AMENDED AGENDA
Regular Hybrid Meeting
Town of Granby
Planning & Zoning Commission
Tuesday, June 10, 2025, at 7:00 pm
Town Hall Meeting Room

RE: Application seeking a Site Plan and Special Permit under Zoning Regulations Sections 3.5.4.3, 8.6.14 and 8.21.4 for a commercial building in the Aquifer Protection Overlay Zone with an illuminated freestanding directory sign and outdoor storage, for property located at 14 Mill Pond Drive, C2 Zone: File Z-7-25.

14 & 18 MILL POND DRIVE: INITIAL STAFF REVIEW COMMENT RESPONSES; 26 MAY 2025

PROPOSED COMMERCIAL FACILITY
#14 MILL POND DRIVE, GRANBY, CONNECTICUT 06035

Type "C-L" Catch Basin:
Scale: N.T.S

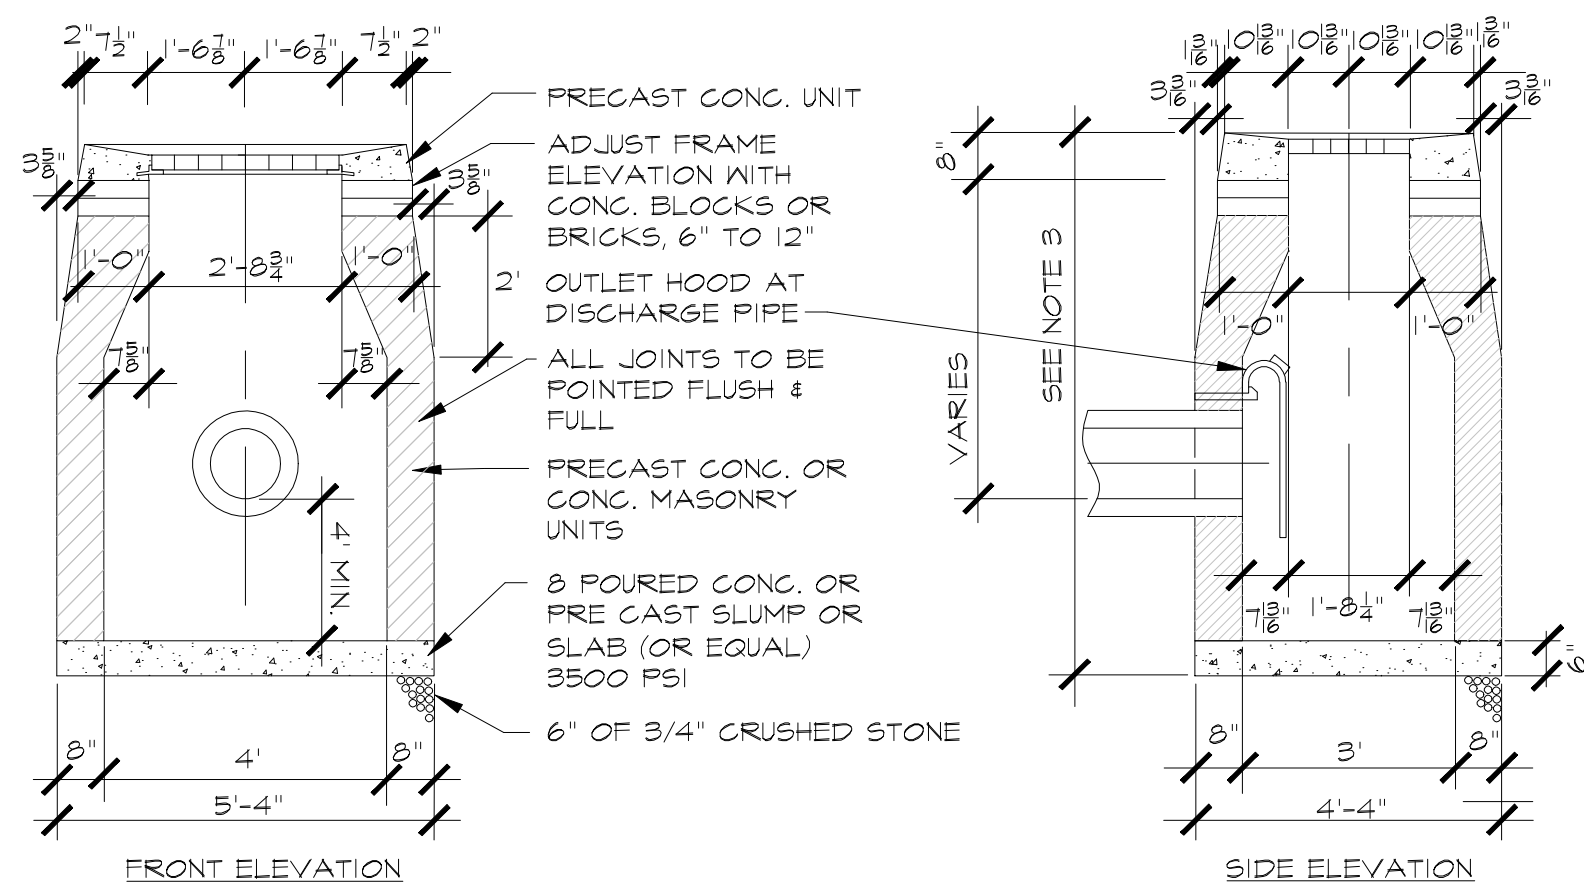
16. Are all catch basins 'CL' type? May want to use a 'C' type for CB#1. ***RELABLED CB #1 AS A TYPE "C" CATCH BASIN, AS NOTED ON SHEETS L.1 & L.3, AND AS DETAILED ON SHEET L.10.***

Biodegradable Slope Stabilization Mat:
Scale: N.T.S

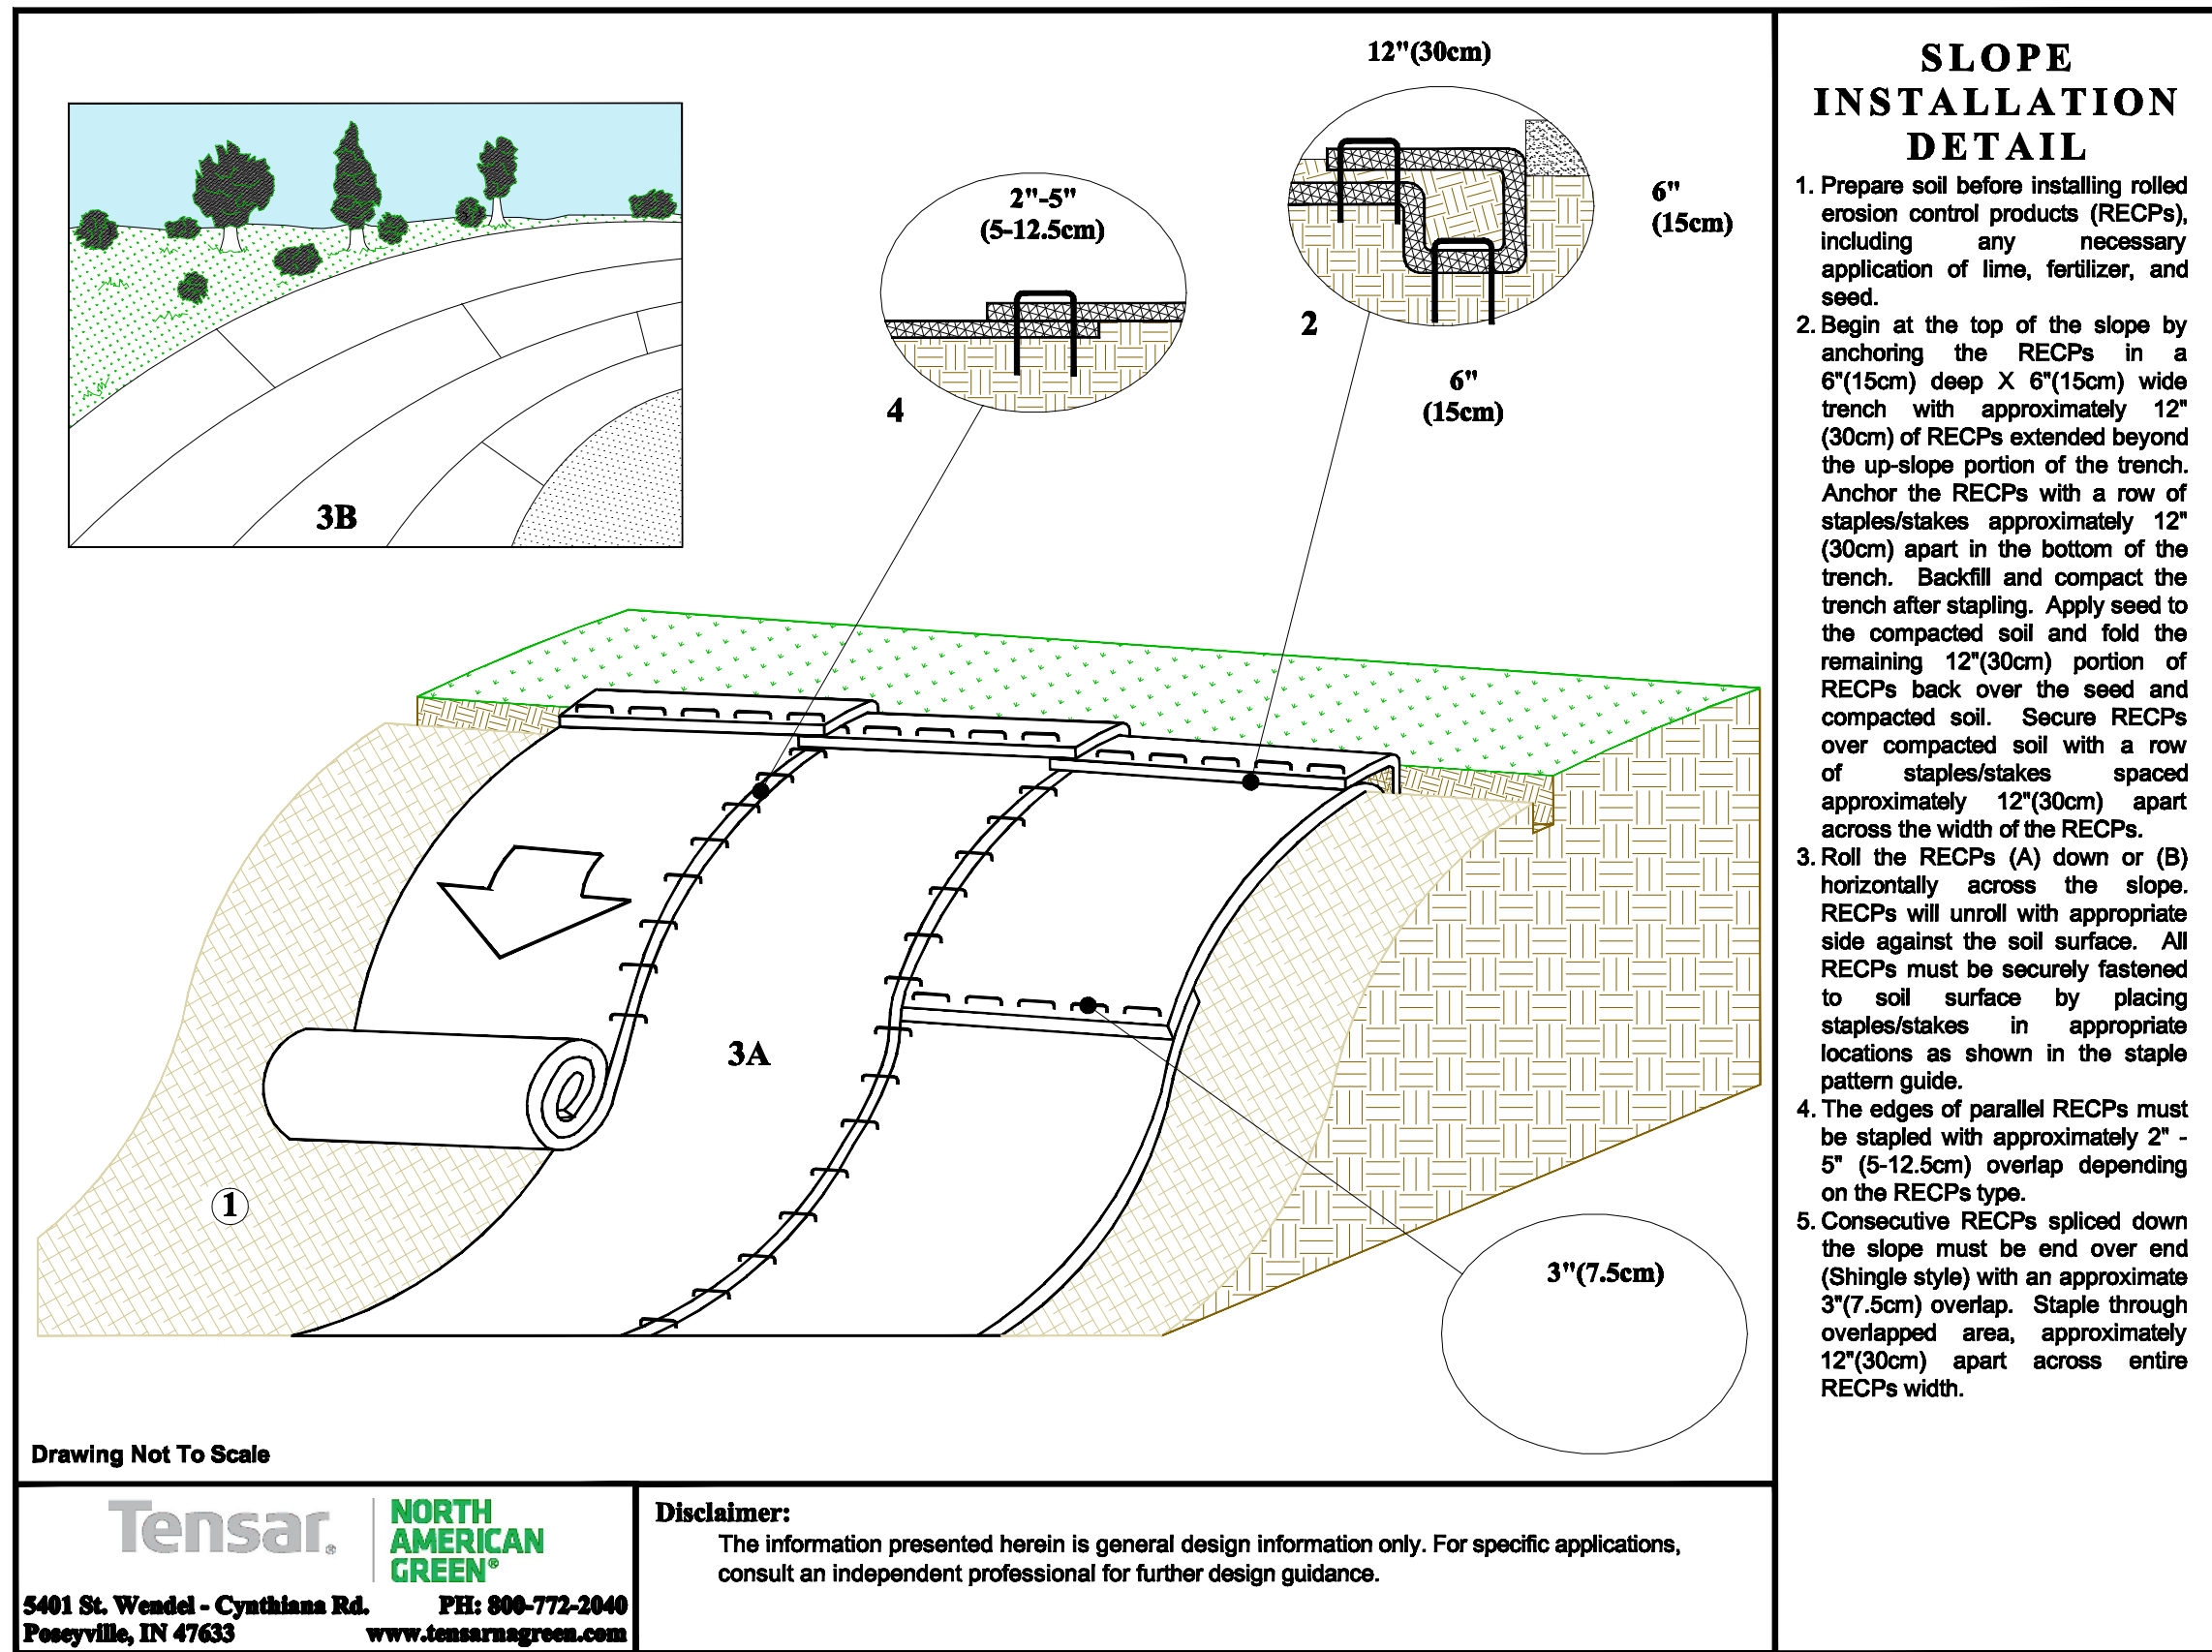
32. The sides of the Water Quality Basin above the rip rap to be stabilized with erosion control matting (ECM). ***RELABLED & GRAPHICALLY SHOWN ON SHEET L.5, AND AS DETAILED ON SHEET L.10.***

Sheet 3: West Building Elevations

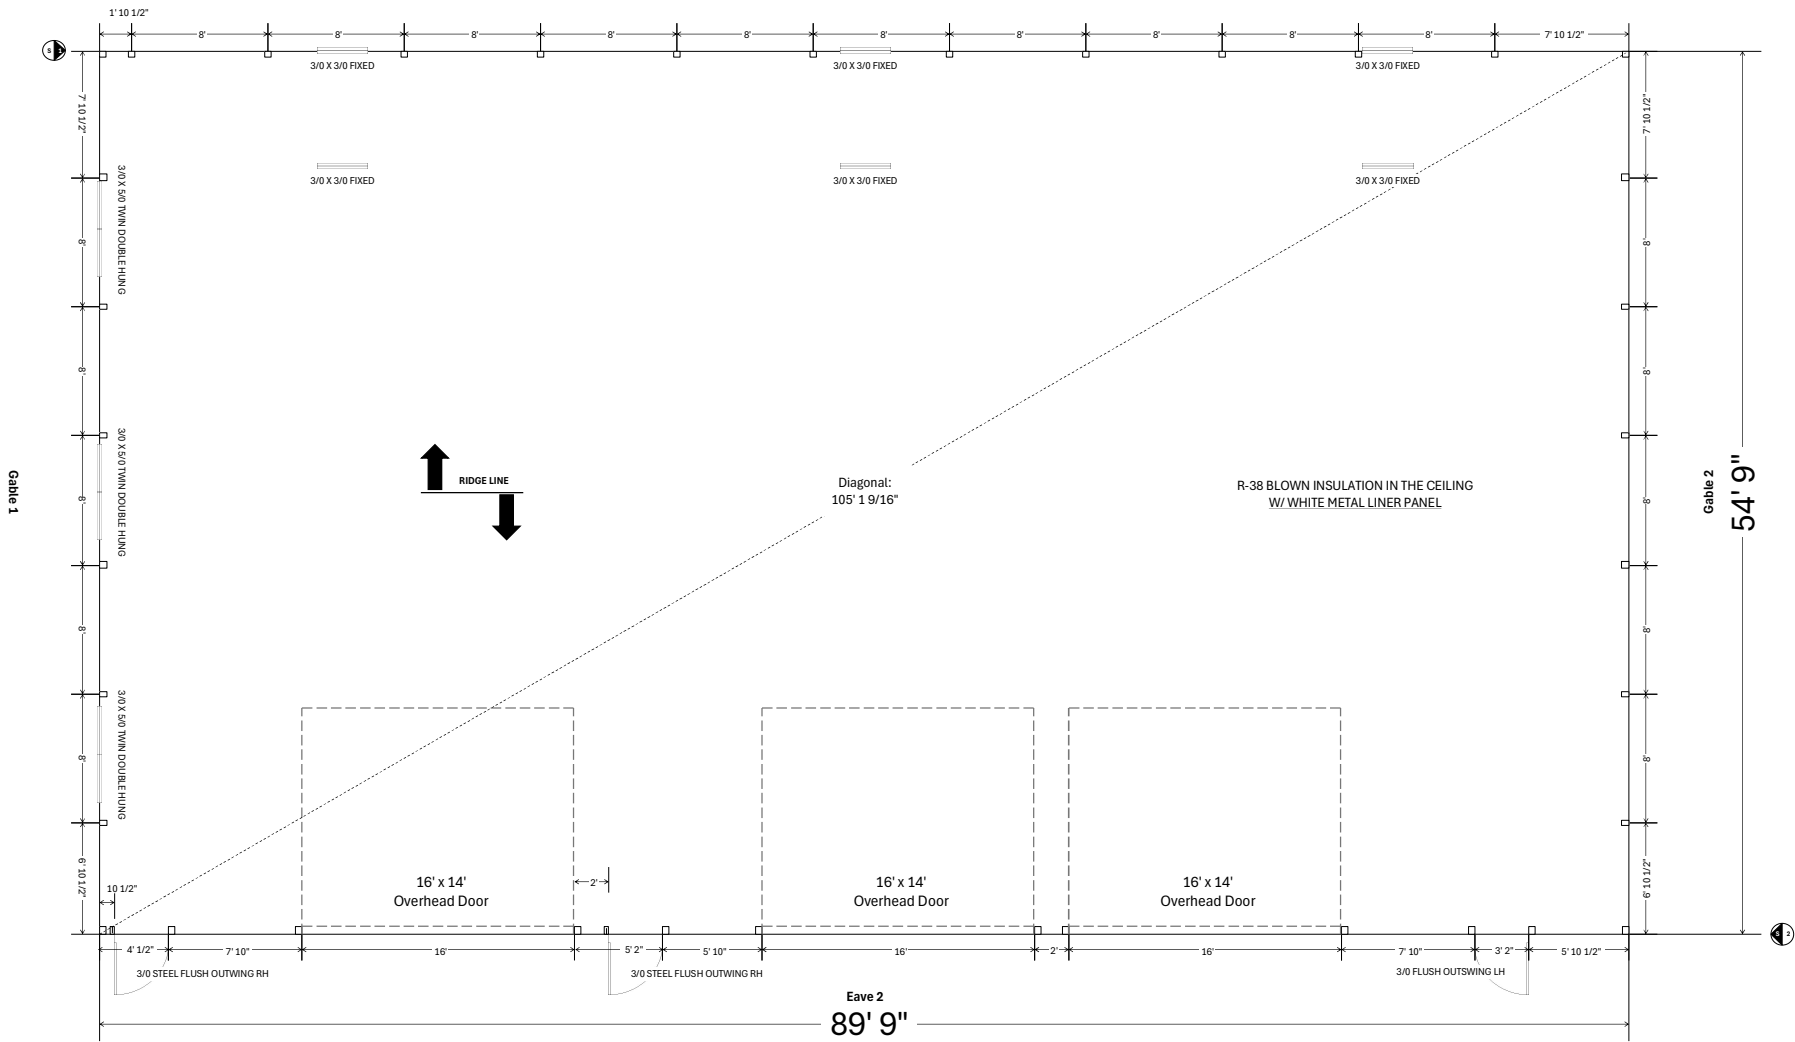
5. The photometric plan shows recessed lights over the doors however, the building elevations do not show an overhang or canopy. Clarify. ***THERE IS A 24" WIDE ROOF EAVE ALL AROUND THE BUILDING PERIMETER TO HOUSE RECESSED FIXTURES.***

6. The site plan shows a pedestrian door on the southern elevation however, the building elevation does not show a door. Clarify. ***THAT DOOR WILL BE RELOCTED ON THE FINAL ARCHITECTURE DRAWINGS PRIOR TO FINAL SUBMISSION.***
